**Re: Fourth Submission Review – High Point Gun Club To 61st Ave Extension - Infrastructure Site Plan**  
Application Number: **DA-1746-40**  
Case Number: **2024-6007-00**

## Fourth Submission Review

**Site Location:**

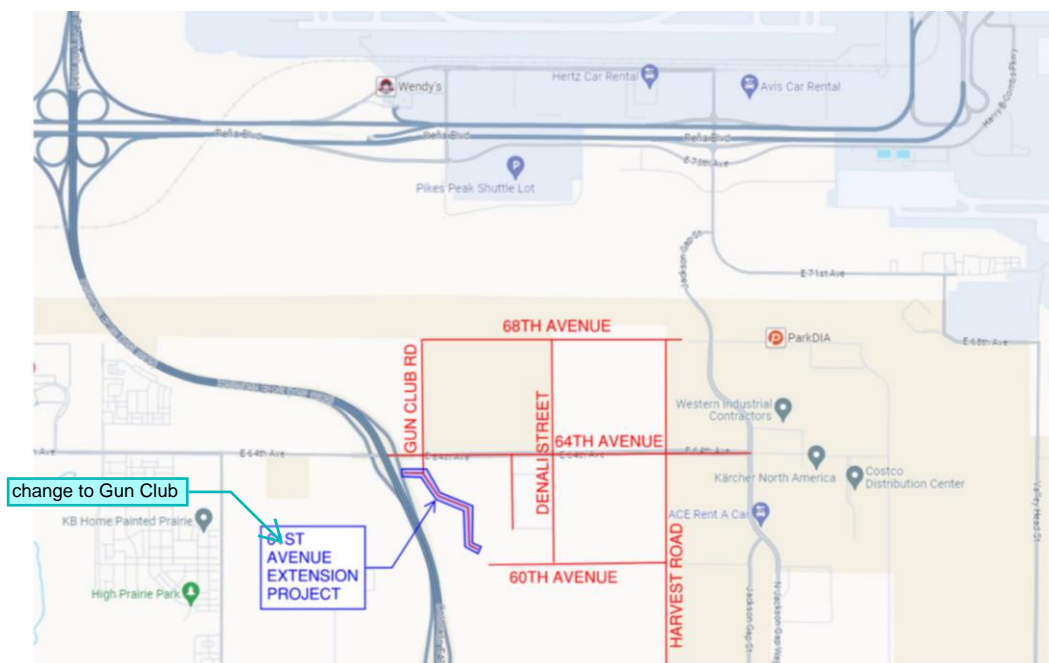
easier to understand saying east of E-470 and xx feet/miles south of E. 64th Ave. Especially since the section, twshp and range aren't shown in the vicinity map
